Docket Number:	23-OPT-02
Project Title:	Darden Clean Energy Project
TN #:	261851-3
Document Title:	Staff Memorandum on Record of Proceedings_Attachment 2
Description:	N/A
Filer:	Ngoc Tran
Organization:	California Energy Commission
Submitter Role:	Commission Staff
Submission Date:	2/18/2025 2:20:37 PM
Docketed Date:	2/18/2025

Subject: BESS Figure

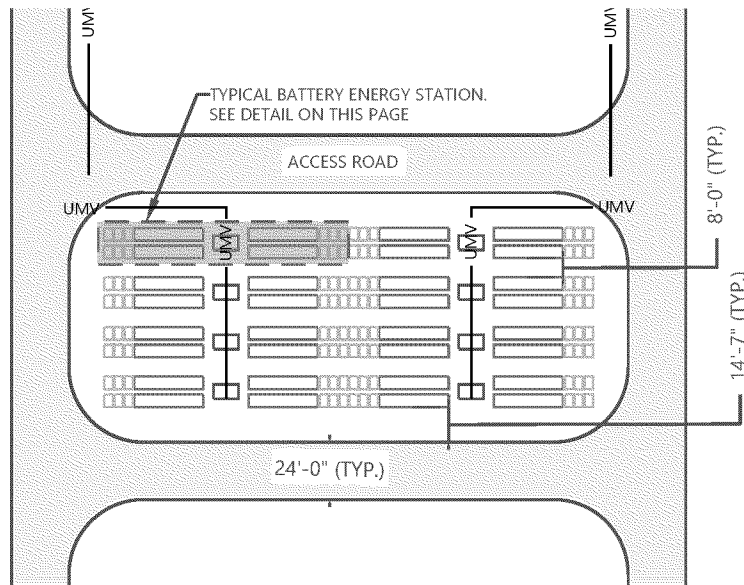
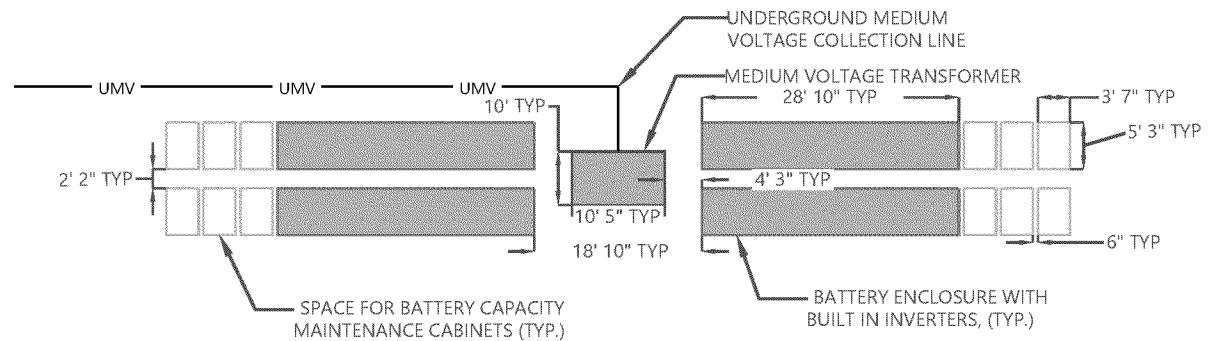
Is this the figure you are referencing as being throughout the application? Staff needs more detailed information than the blue polygons on Figure 3-2 labeled "BESS". Staff needs to know where the "anticipated location of the typical battery station" would be in relation to other equipment to determine if there is adequate clearance and setbacks from the proposed locations of other equipment.

BESS DETAIL AND LAYOUT

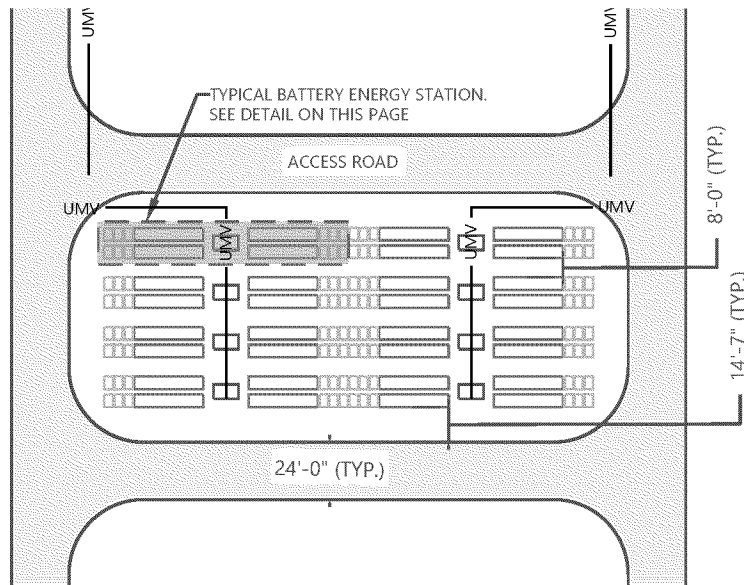
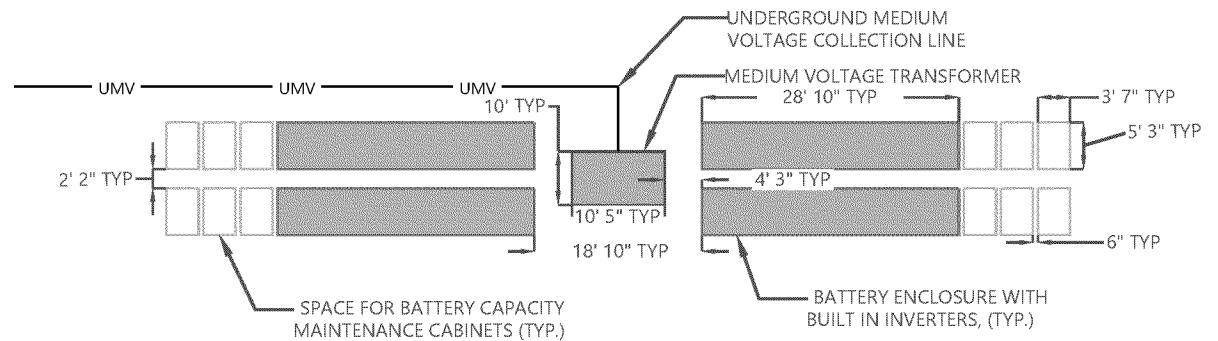
Is this the figure you are referencing as being throughout the application? Staff needs more detailed information than the blue polygons on Figure 3-2 labeled "BESS". Staff needs to know where the "anticipated location of the typical battery station" would be in relation to other equipment to determine if there is adequate clearance and setbacks from the proposed locations of other equipment.

In looking back at notes from our call on Wednesday and at the data request REV 1 DR HAZ-2 I am still unclear on what this ask is: "*The Conceptual BESS Layout should identify the anticipated location of the typical battery station within the overall site in relation to other equipment.*" Our project location figures throughout the application materials show the approximate location of the BESS near the other project components. Specifically, what does "*other equipment*" mean? If we update the figure previously provided (showing the fire protection components) to include the exact components listed in REV 1 DR WS-1, does that satisfy the ask in HAZ-2?
